# Proposal for Compliance Interconnect Method of Determining SAS Driver Compliance

Summary: It is proposed to extend Figure 30, “*Dr, Dt, Cr or Ct Compliance Point Connector*”, to incorporate the Compliance Interconnect concept described in XAUI (ref: IEEE P802.3ae Draft 5.0, Clause 47, sec. 47.4.1). This approach enables the use of driver equalization/emphasis and minimizes measurement issues associated with near-end electrical measurements.

Figure 30. Test loads

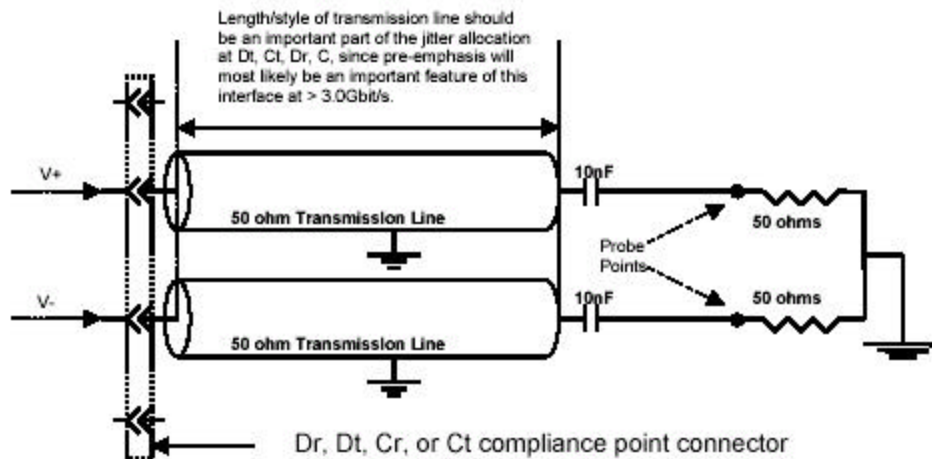
This proposal would add specific definition to the above transmission lines. The driver being characterized would then have to meet the far-end specs through this *Compliance Interconnect*. (As stated in 47.3.3.5 of the IEEE 802.3ae draft specification, “The driver

This specification was developed to represent a reasonably worst case 20 inch PCB trace. Since the XAU1 application and speed (3.125 Gb/s) is so close to the 3 Gb/s SAS application, I would recommend adopting this spec as is.

Figure 47-6—Compliance interconnect magnitude response and ISI loss.

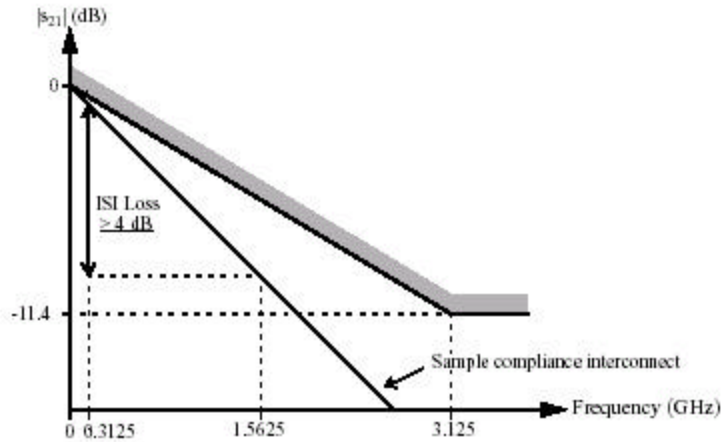
The compliance interconnect is a 100 Ω differential system specified with respect to transmission magnitude response and intersymbol interference (ISI) loss. The compliance interconnect limits have been chosen to allow a realistic differential interconnect of about 50 cm length on FR4 epoxy PCB. See 47.3.5 for a more detailed description of the target XAU1 interconnect. The transmission magnitude response,  $|s_{21}|$ , of the compliance interconnect in dB satisfies Equation (47-2).

$$|s_{21}| \leq |s_{21}|_{limit} = -20 \log(e) \times [a_1 \sqrt{f} + a_2 f + a_3 f^2] \tag{47-2}$$

where  $f$  is frequency in Hz,  $a_1=6.5 \times 10^{-6}$ ,  $a_2=2.0 \times 10^{-10}$  and  $a_3=3.3 \times 10^{-20}$ . This limit applies from DC to 3.125 GHz. The magnitude response above 3.125 GHz does not exceed -11.4 dB. The ISI loss, defined as the difference in magnitude response between two frequencies, is greater than 4.0 dB between 312.5 MHz and 1.5625 GHz. The magnitude response and ISI loss limits are illustrated in Figure 47-6.
